**CONTINENTAL MOTORS® AIRCRAFT ENGINE  
CRITICAL SERVICE BULLETIN**

**CATEGORY 2  
CSB19-01**

- SUBJECT:** Fuel (Primer) Diverter Valve Assembly
- PURPOSE:** To assist Owners, Operators, and Maintenance Facilities with instructions to remove the fuel diverter valve assembly and provide available options to the fuel injection system for continued service.
- COMPLIANCE:** Within the next 25 hours of engine operation or the next scheduled inspection or engine servicing, whichever occurs first.

Figure 1. Fuel Diverter Valve Assembly, typical

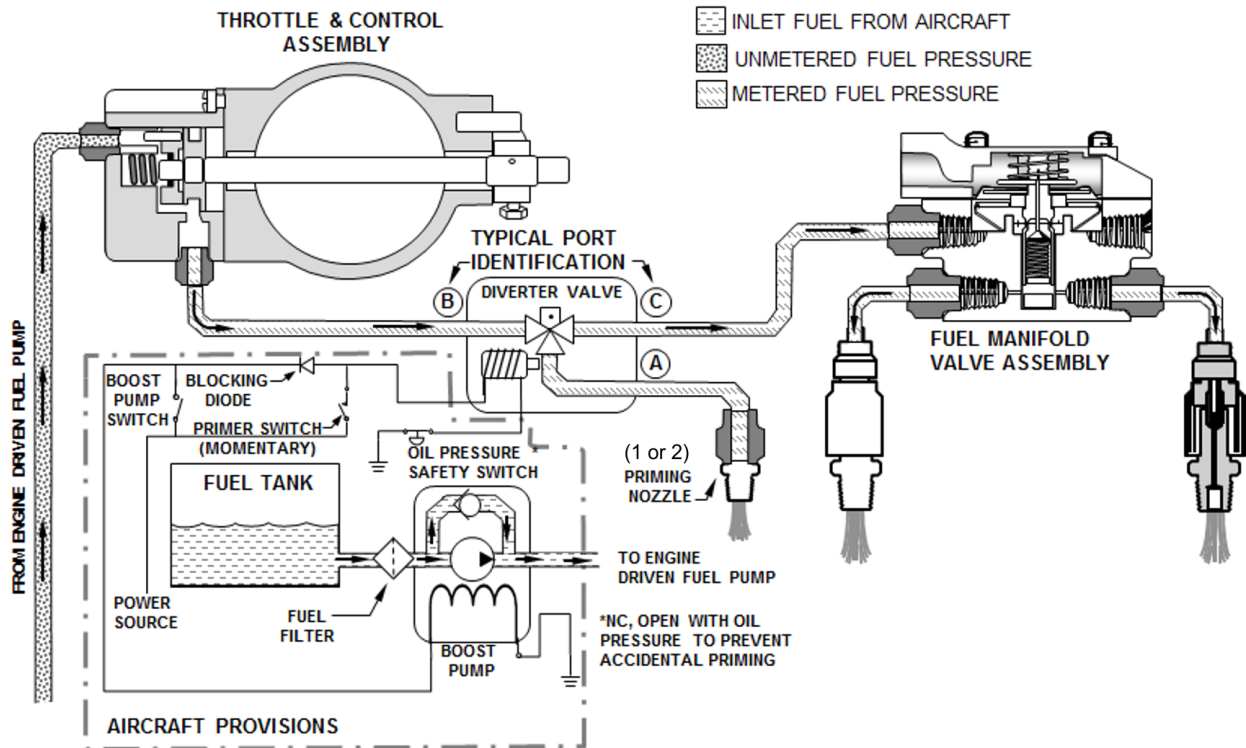
1. Verify your cross-flow engine has a fuel diverter valve assembly (P/N 633862-1, 642199-1, (14V), or 633862-2, 649268-2 (28V, as shown in Figure 1).

- a. Remove fuel diverter valve assembly (tubes and connectors) between the throttle and control assembly and fuel manifold valve assembly (see Figure 1, port identification B & C and Figure 2 through Figure 4, example configurations).
- b. Remove tube/hose assembly, as applicable, (see Figure 1, port identification A and Figure 2) between fuel diverter valve assembly and priming nozzle(s).
- c. Remove disconnected priming nozzle connector(s) and tube assemblies connected to induction system (location references see Figure 2 and Figure 7).

**Figure 5. Cylinder Drain Connector, P/N 632068 superseded by 655742**

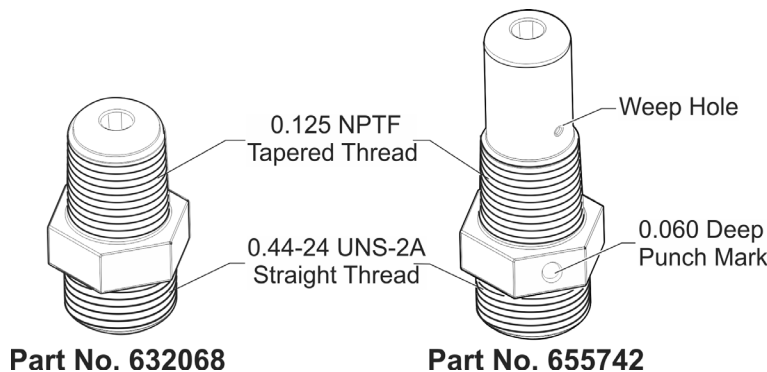
The cylinder drain connector serves the same priming function as the primer diverter valve and allows the removal of the fuel diverter valve assembly from current production model specifications. Inspect for the current production cylinder drain connector (P/N 655742). The cylinder drain can be identified by a 0.060 deep punch mark in the wrenching flat (see Figure 5, P/N 655742).

1. If the cylinder drain is identified as P/N 655742, replacement is not necessary.
2. If the cylinder drain cannot be identified, perform an “Induction System Drain Inspection” according to M-0, Standard Practice Maintenance Manual, Section 6. If applicable, remove and replace cylinder drain connector(s) with current P/N 655742 (quantity based on number of engine cylinders).

**Figure 6. Hose Installation, IO-360-ES; TSIO-360-MB, SB**

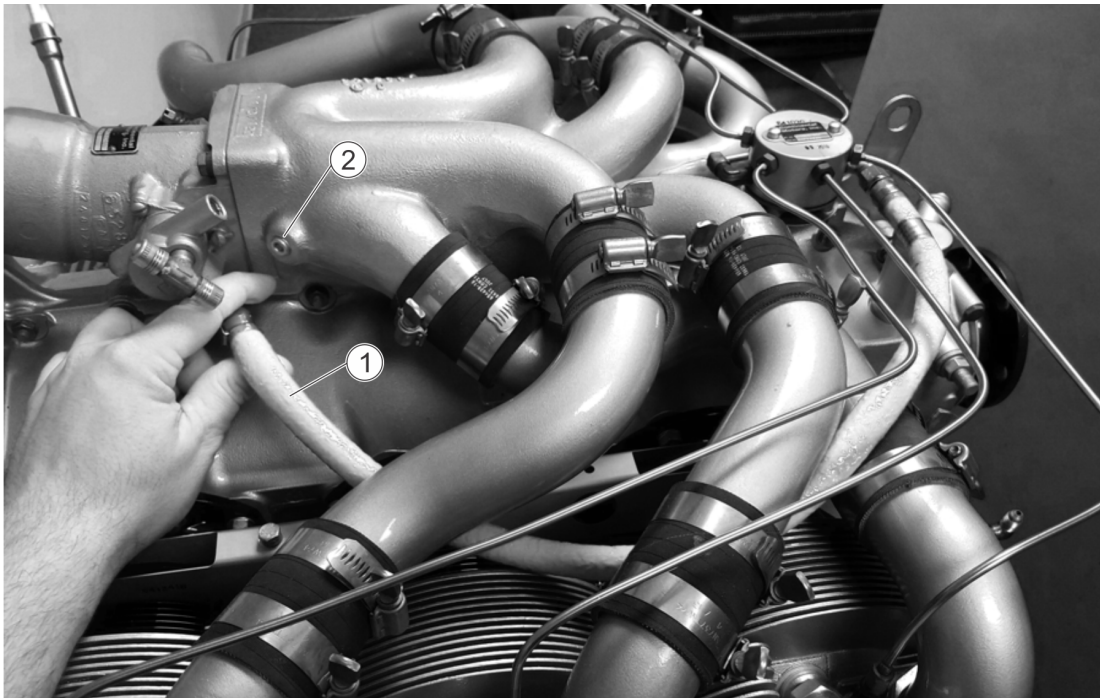
1. Install new hose/tube assembly (reference Table 2 through Table 5 and Figure 6 through Figure 9) between throttle body (mixture control outlet) and fuel manifold valve inlet fitting.
2. Lubricate the hose/tube connector threads with clean 50 weight aviation engine oil.
3. Torque tube or hose fittings to the values specified in the latest revision of M-0, "Standard Practice Maintenance Manual, Appendix B."
4. Install plug(s) (reference applicable parts list tables) to terminate induction tube port(s). Lubricate the plug threads with Loctite® 592 PST thread sealant and torque to the values specified in the latest revision of M-0, "Standard Practice Maintenance Manual, Appendix B."

**Figure 9. Hose and Clamp Assembly, TSIO-520-BE; TSIO-550-A, B, C6B, E**

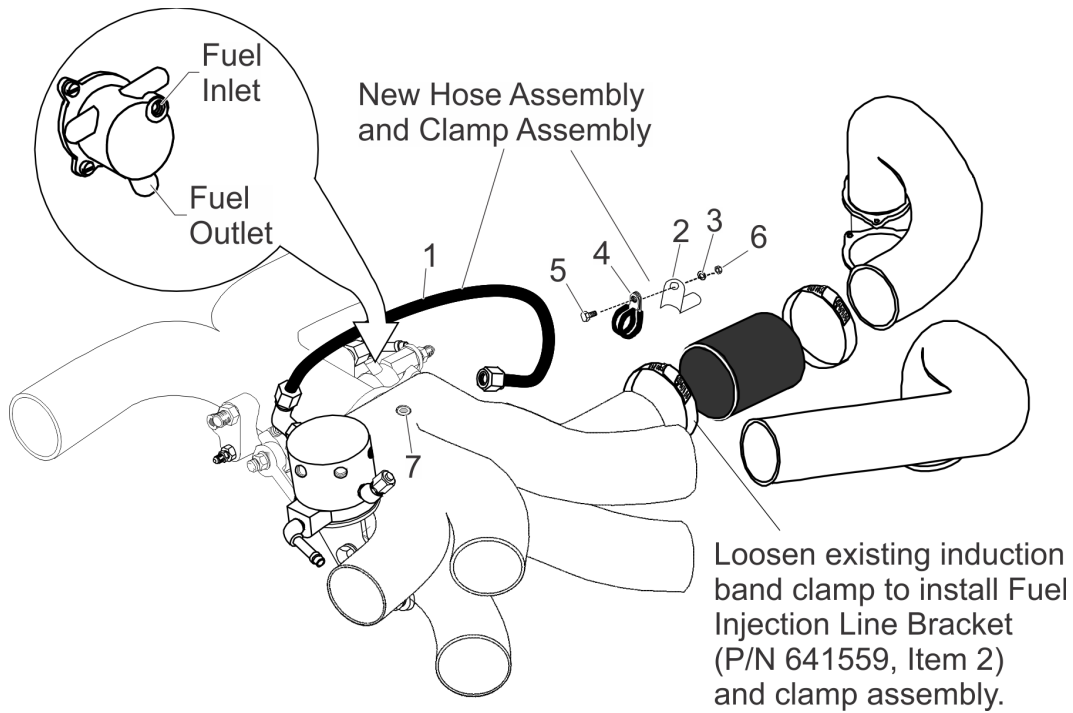
- Reference Figure 9, to assemble the hose assembly (P/N 646644S6S23.00) and clamp assembly (fuel injection line bracket (item 2) for the TSIO-550-C6B engine. Loosen the induction clamp at the induction joint and insert bracket (item 2) under the induction clamp.
- Reposition the induction clamp on the induction tube and torque to the values specified in the latest revision of M-0, “Standard Practice Maintenance Manual, Appendix B.”

NOTE: If the clamp will not tighten or remain torqued to Appendix B specifications, the clamp is unserviceable, replace the induction clamp and perform a service inspection according to M-0, 6-4 “*Induction System Inspection.*”

7. Torque hose and clamp fittings to the values specified in the latest revision of M-0, “Standard Practice Maintenance Manual, Appendix B.”
